Lithium LV POD Schematic (32MLF)

PCB: PDC-9303 **
PCA: 121-30300 *A

CYPRESS SEMICONDUCTOR © 2005		
Title: Lithium LV 32MLF POD		
Size: C	Document Number: REF-13437	Rev: *A
Date: Tuesday, April 04, 2006	Sheet 1 of 1

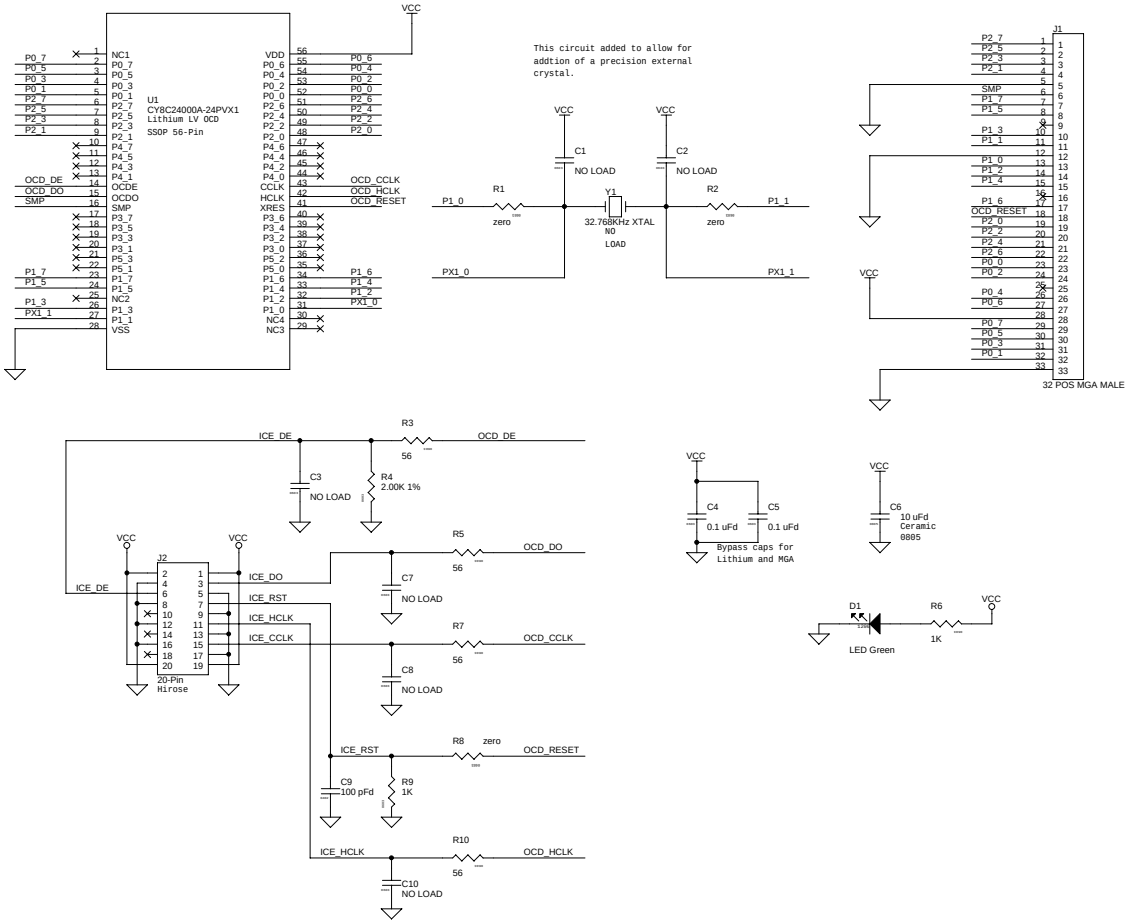
Rev 0.2 - Changed the cyrstal from HC49 to a cylinder watch crystal. (2/6/06)

Rev 0.3 - Changed R4 from a 1k to a 2k resistor. This was done to allow the pod to work when powered at 5V. (4/4/06)
